**Browns Ferry Nuclear Plant (BFN)
Unit 1**

Technical Specifications (TS) Change 473

AREVA Fuel Transition

**Part 2: ANP-2860P
Browns Ferry Unit 1 -- Summary of Response to Requests for Additional Information
(Non-Proprietary)**

Figure 5-1 Geometry

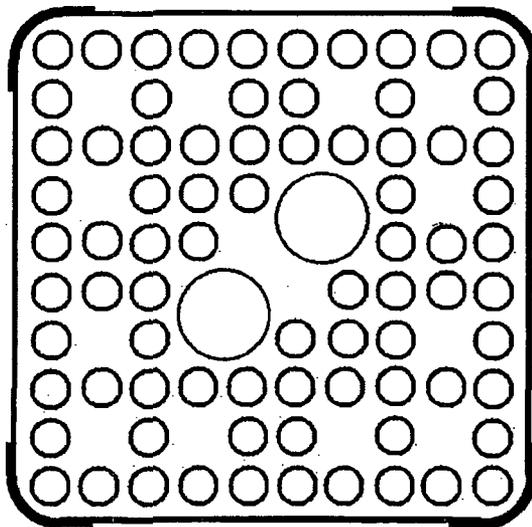
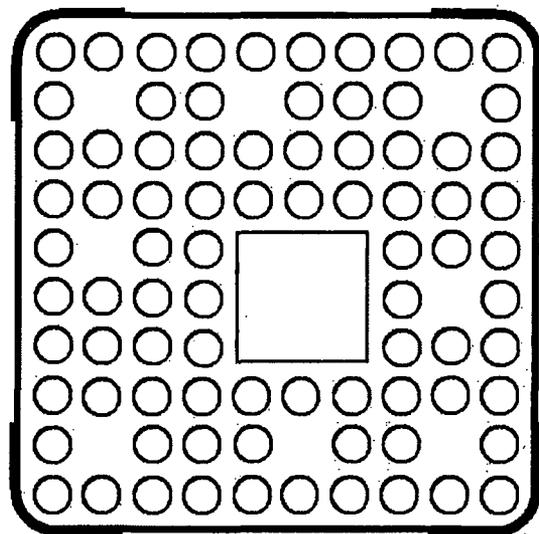
The [] void-quality correlation has been qualified by AREVA NP against both the FRIGG void measurements and ATRIUM-10 measurements. The cross-sectional views of these two test channels are illustrated in Figure 5-1 along with the geometry of the GE14 fuel design. Despite the significantly different geometrical configurations (between FRIGG and ATRIUM-10), the behavior of the [] calculations when compared to the measured data is remarkably similar as illustrated in Figure 5-2. This similarity of results indicates that the [] void-quality correlation is applicable to a range of geometries larger than the differences between ATRIUM-10 and GE14 and thus is equally applicable to the GE14 fuel design in the BF1 Cycle 9 mixed core configuration.

Figure 6-1 SLMCPR Radial Power Distribution High-Powered Assemblies Depleted Voids

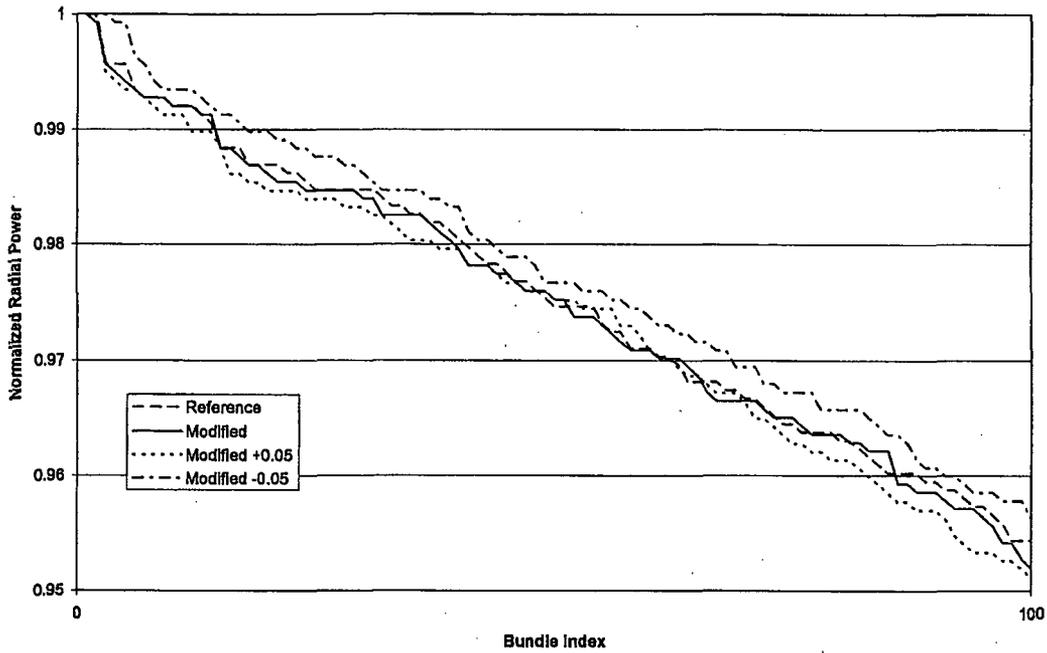
For Section 6.7.2, the change in the void-quality correlation was imposed over all fuel in the core from beginning of life. No changes were made to the fuel loading and rod patterns. The result of this was that a reduction in void resulted in more assemblies at higher power. The radial peaking factors of the high-powered assemblies that contributed to rods in boiling transition were slightly more "flat" and resulted in a slightly higher SLMCPR. Figure 6-1 shows the slight differences in radial distributions.

Figure 6-2 SLMCPR Radial Power Distribution High-Powered Assemblies Instantaneous Voids

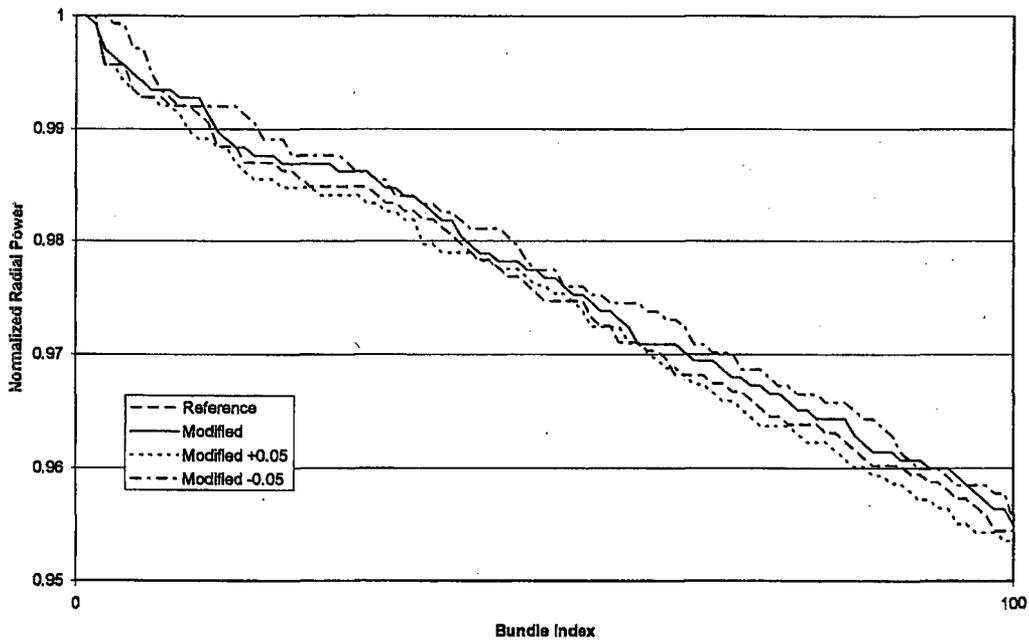
The sensitivity analysis of Section 6.7.2 was repeated for an instantaneous change in voids. For an instantaneous change in voids, the SLMCPR trends were the same as in Section 6.7.2; however, the change is small for both depleted and instantaneous void change, i.e., an SLMCPR change of -0.003 for +0.05 voids and $+0.002$ for -0.05 voids. The sensitivity can be explained by the small radial power distribution shifts in Figure 6-2 and Figure 6-3. It is

Figure 6-7 Initial Axial Power Shape - Depleted Voids

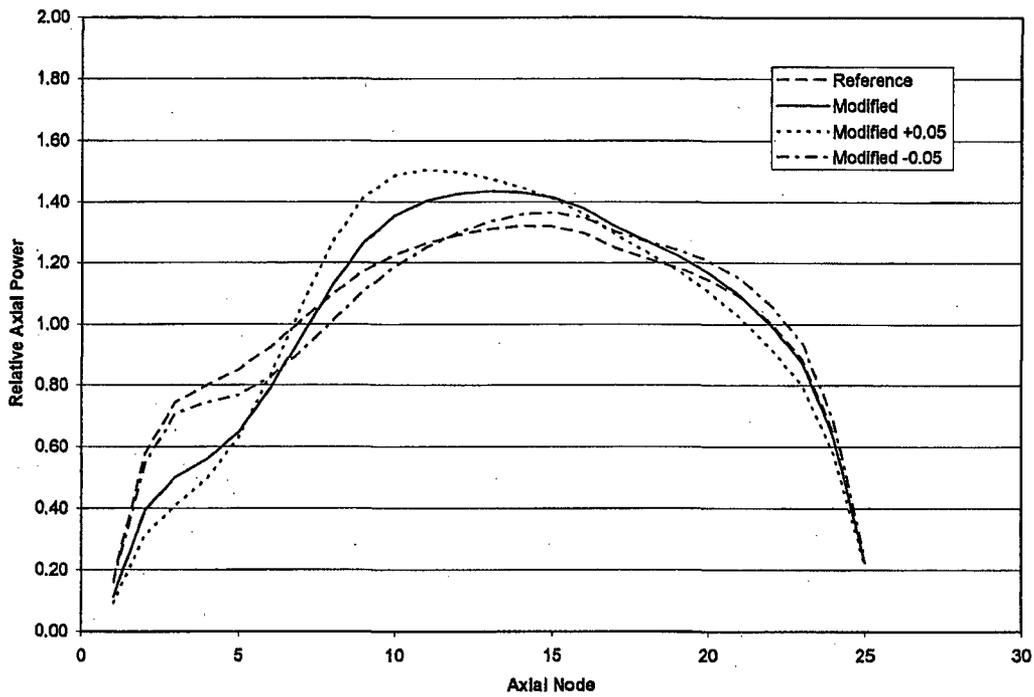
- The limiting bundle: core location and initial radial peaking factor (Table 6-4).
- Initial axial power shape (Reference case) (Figure 6-7).
- Plots of the perturbed axial power shapes (initial conditions) (Figure 6-7).

Figure 6-8 Initial Radial Power Distribution From Transient Analyses - Depleted Voids

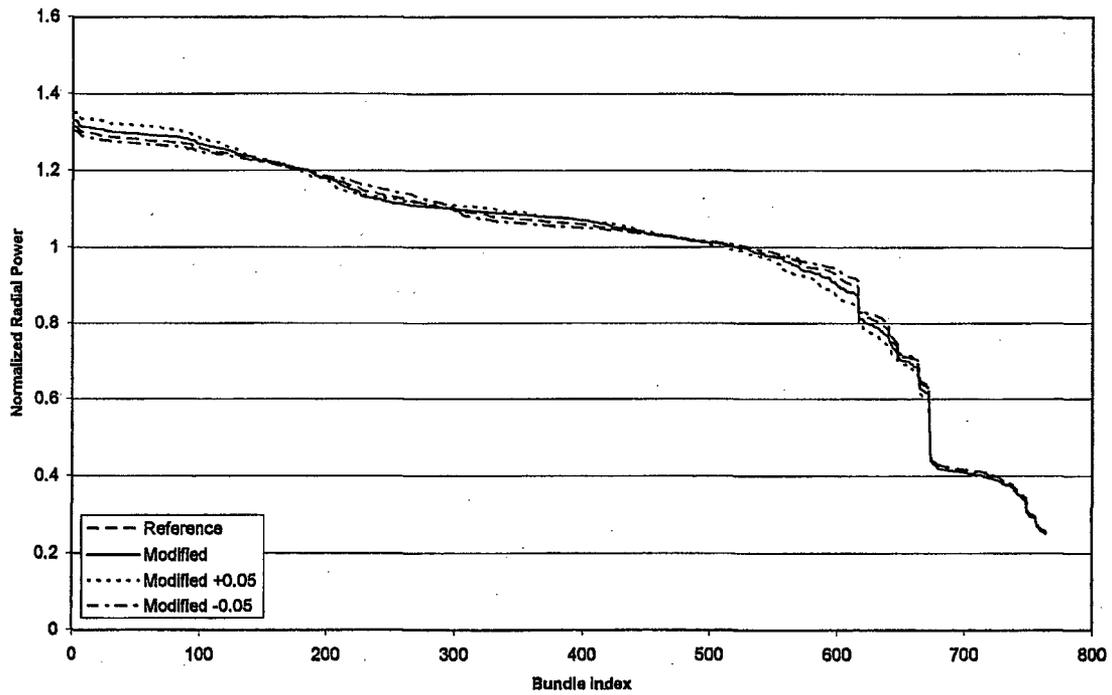
- Plots of the perturbed radial core power shapes (initial conditions) (Figure 6-8).
- Plots of transient limiting bundle peak rod heat flux at axial heights of (x/L) 25%, 50%, and 75% (Figure 6-9 to Figure 6-11).
- Plots of transient limiting bundle mass flow rate at axial heights of (x/L) 0%, 25%, 50%, 75% and 100% (Figure 6-12 to Figure 6-16).
- Plots of transient critical power ratio (CPR) (Figure 6-17).
- A comparison of the predicted power pulse heights and widths (Table 6-3).

Figure 6-36 ATRIUM-10 LHGR Limit

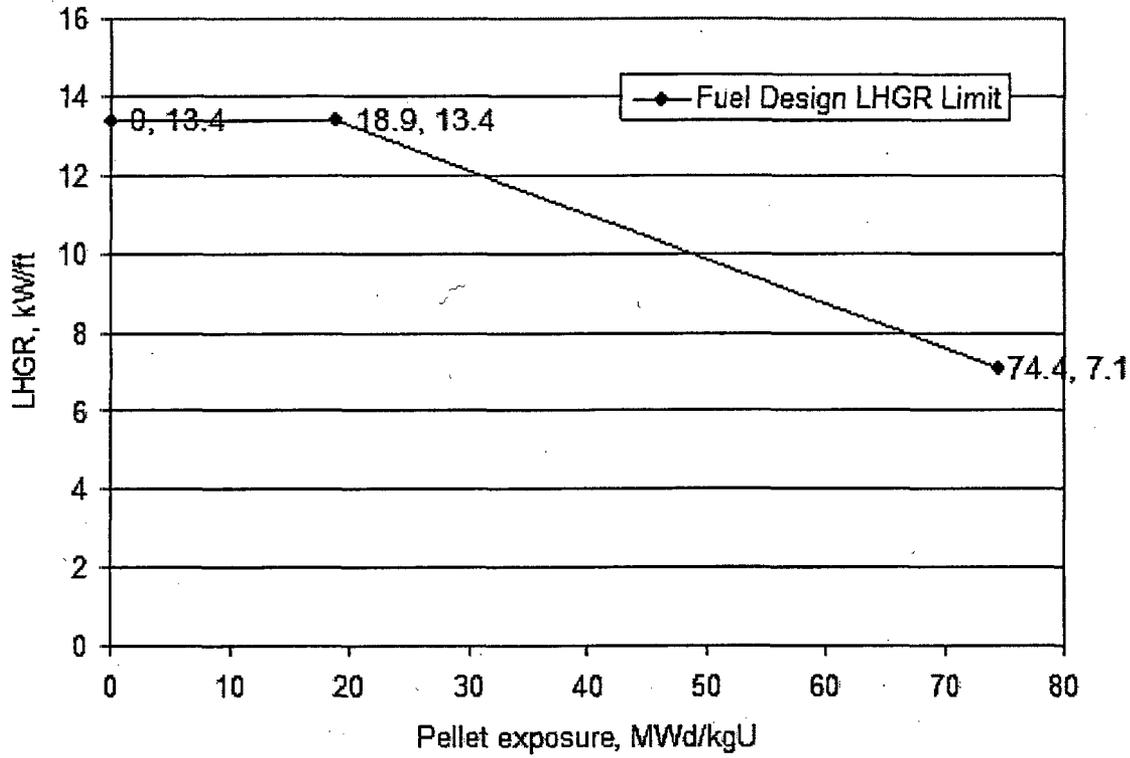
A typical ATRIUM-10 BOL LHGR limit is [] kW/ft. Figure 6-36 shows a typical LHGR limit for the ATRIUM-10 fuel. Note that the limit is now specified as a function of pellet exposure while previous limits are based on an assembly planar exposure.

Figure 8-1 SRV Flow During ATWS Overpressurization

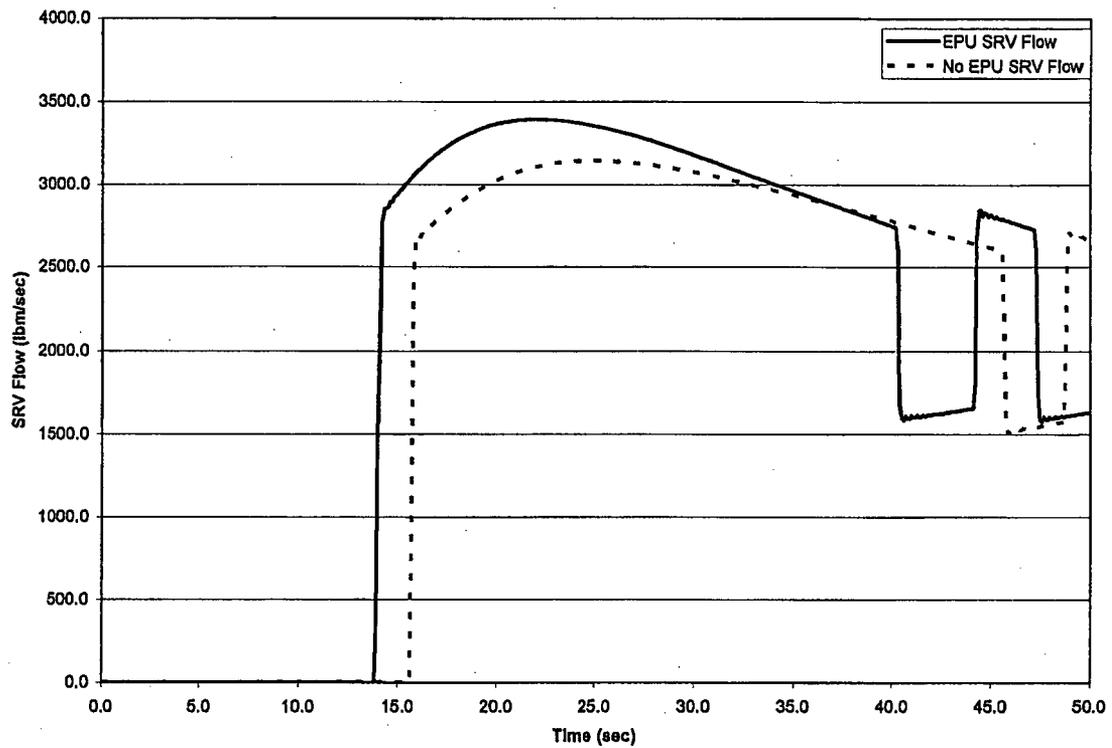
A plot of total SRV flow during an ATWS overpressurization is provided in Figure 8-1 for EPU and non-EPU operation of a Browns Ferry Unit 3 Cycle 14 design.

Figure 6.1 Browns Ferry Cold Critical Benchmark Results

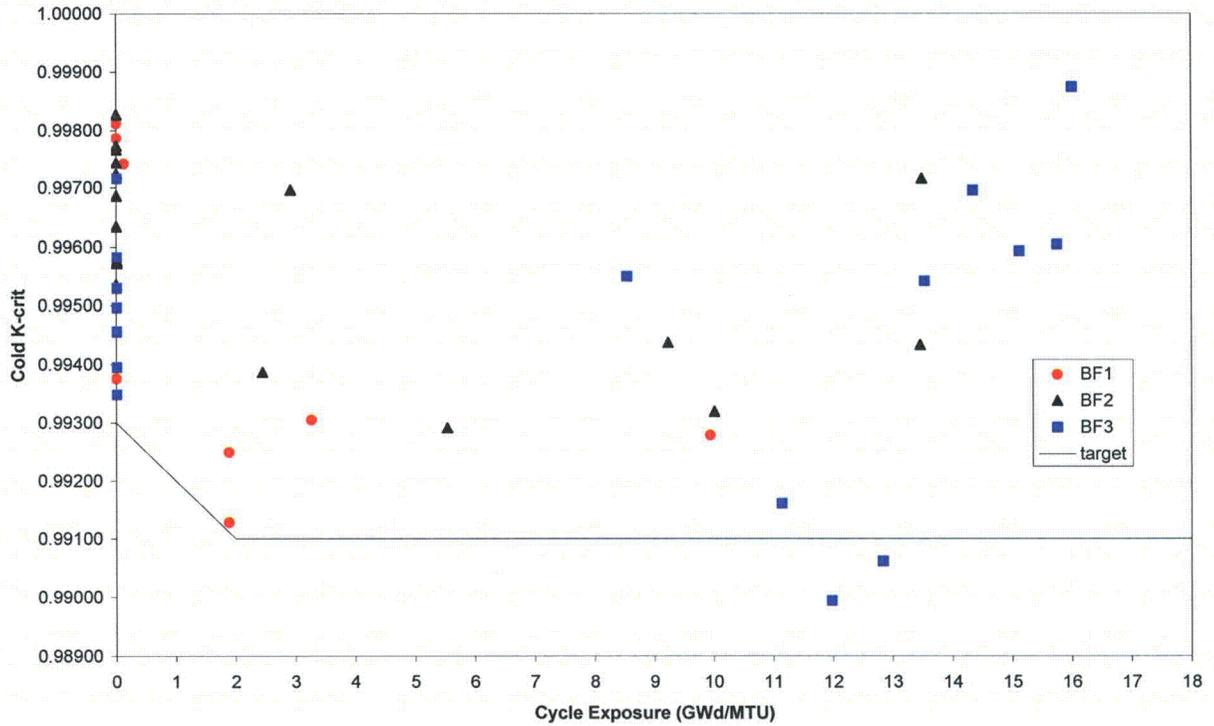
As part of the design process for developing the fuel/core design for Browns Ferry Unit 1 Cycle 9 it is necessary to establish a target cold critical eigenvalue. The approach taken to determine the target cold critical eigenvalue for Browns Ferry Unit 1 is more conservative than that described above due to the extended shutdown of the unit. Information from Browns Ferry Units 2 and 3, as well as Unit 1, have been used to determine the target cold critical eigenvalue. A summary of the calculated cold critical for the three Browns Ferry Units is presented in Figure 7-1. This figure includes cold critical data from any Browns Ferry cycle that contained GNF fuel. The target cold critical eigenvalue used for Unit 1 Cycle 9 design is shown in Figure 7-1. The target was conservatively set to bound all the measured cold criticals for the three units. This conservative determination of the target, together with the conservatively determined design goal of $1\% \Delta k/k$, ensures conservative determination of shutdown margin for the Unit 1 Cycle 9 design.
